**RE: Multi-Specialty Clinic
Grading and Drainage Plan
Engineer's Stamp Date 11-20-2015 (File: M15D026B)**

RE: Multi-Specialty Clinic Grading & Drainage (File M15-D026B)

Please find the following responses addressing staff comments from correspondence dated July 18, 2015 listed below:

Profile - 2 - Base

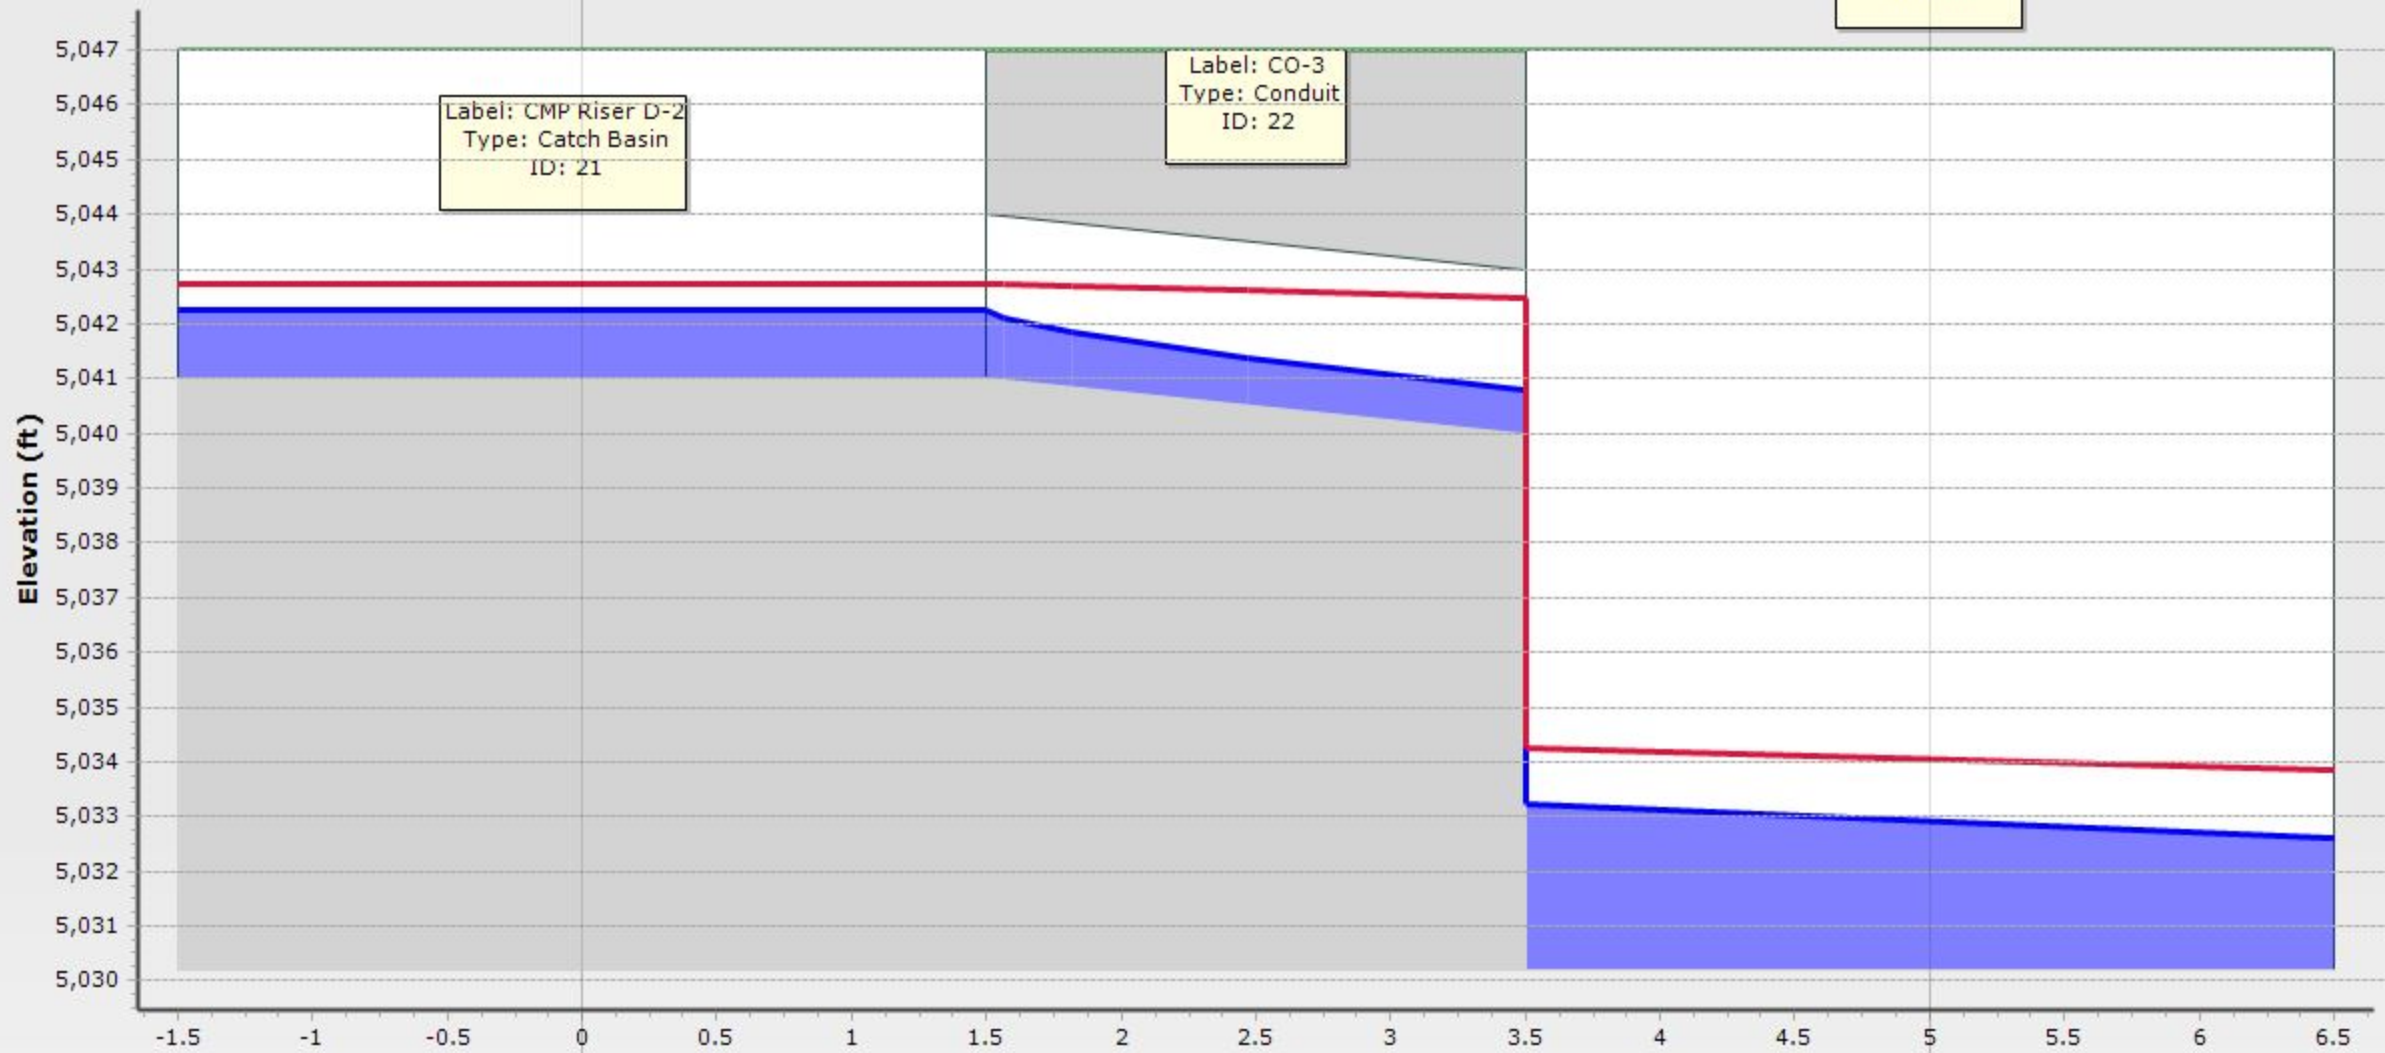
9. Reprint the StormCAD output for "Profile-2" (pipe CO-3), it is not legible in the report.

Response: We have reprinted the StormCAD output for "Profile 2" for inclusion in the report.
